UNITED STATES  
NUCLEAR REGULATORY COMMISSION  
WASHINGTON, D.C. 20555-0001

SAFETY EVALUATION BY THE OFFICE OF NUCLEAR REACTOR REGULATION  
RELATED TO ALTERNATIVE REPAIR OF THE CORE SHROUD VERTICAL WELDS  
NINE MILE POINT NUCLEAR STATION, UNIT NO. 1

DOCKET NO. 50-220

Figure 1-1. Nine Mile Point - Unit 1  
NMP-1 Core Shroud Welds

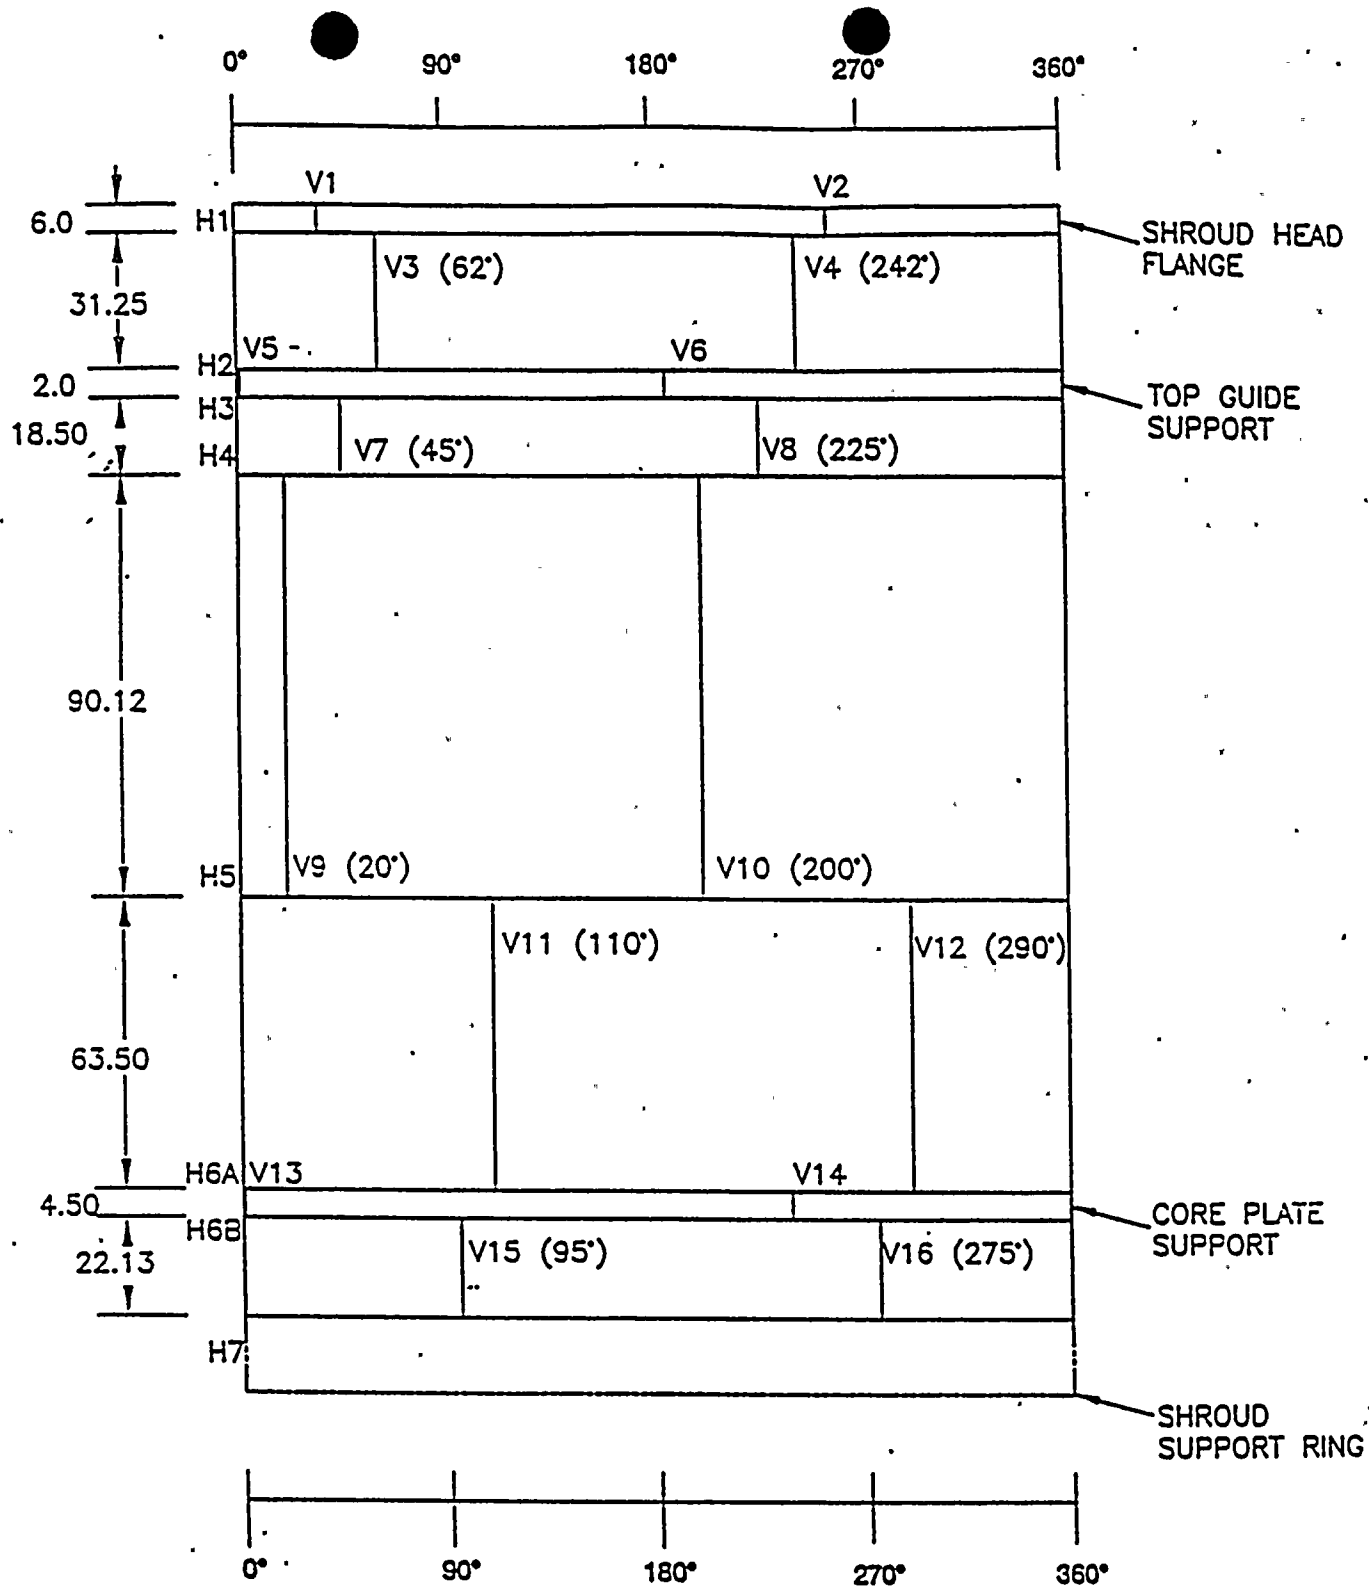
The repair clamp design and installation drawings are provided in NMPC's application. Some of these drawings are extracted and attached to this SE. Attached Figure 1-1 shows the locations of the NMP1 core shroud welds. The NMP1 repair plan addresses vertical welds V4, V9, and V10, and the repair clamps can be installed on each weld independently; i.e., depending upon shroud inspection results, any one, two, or three welds may be repaired with these repair clamps. Attached Figure 1-3 shows the vertical weld clamp assembly installed across vertical weld V4. Attached Figure 1-4 is an exploded view of the vertical weld clamp assembly before installation across vertical weld V9 or V10.
